Product Change Notification (PCN)

PCN Number: PCN_WPME-FISM_2_20260831 Affected Series: WPME-FISM Affected Part Number: see table "PART NUMBER, REVISION & DATASHEET" PCN Date: 2026-05-31 (YYYY-MM-DD) Effective Date: 2026-08-31 (YYYY-MM-DD)	Change Category: ☐ Equipment/Location ☒ General Data ☐ Material ☐ Process ☐ Product Design ☐ Shipping/Packaging ☐ Supplier ☐ Software
Contact: Product Management Phone: +49 (0) 7942 - 945 5001 Fax: +49 (0) 7942 - 945 5179 E-Mail: pcn.eisos@we-online.com	Datasheet Change: ☒ Yes ☐ No Attachment: ☐ Yes ☒ No

Before change	After change

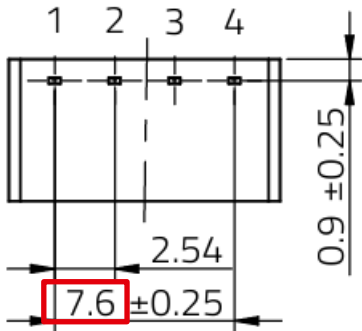
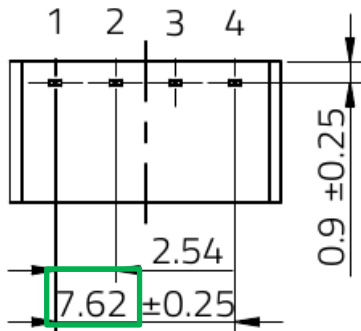
The pitch of the mechanical dimension drawing has been adjusted by adding the second digit after the decimal point.
